Richland, WA October 31 – November 2, 2006

ANP-10249P: ACE/ATRIUM-10 Critical Power Correlation - KRG:06:005

AREVA NP Inc.

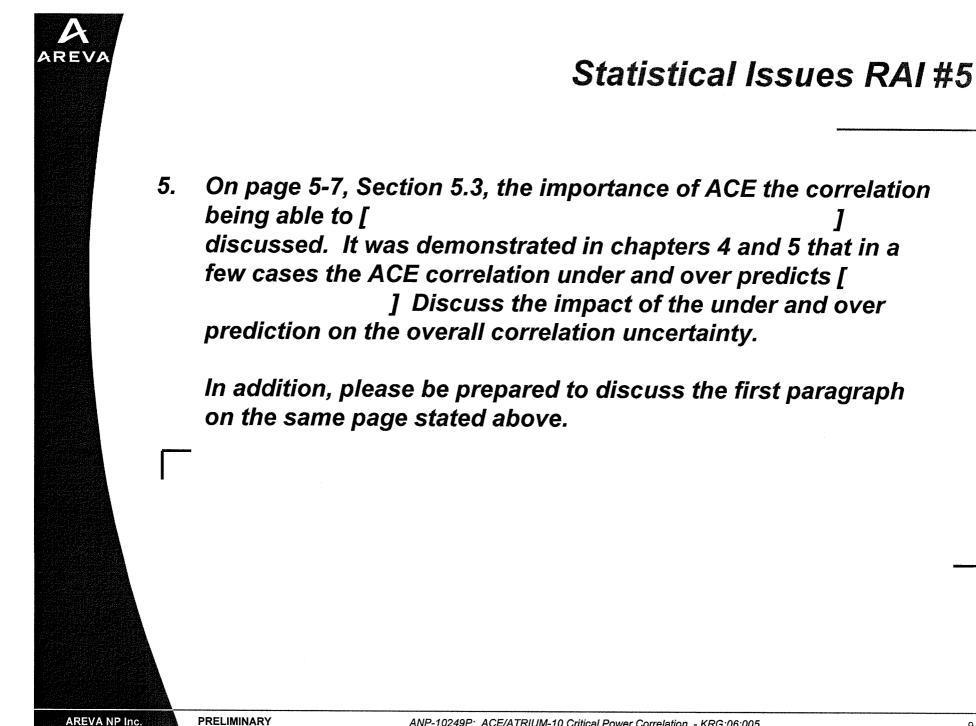
4. Please be prepared to this discuss and provide additional information regarding Figure 4.8 on page 4-8.
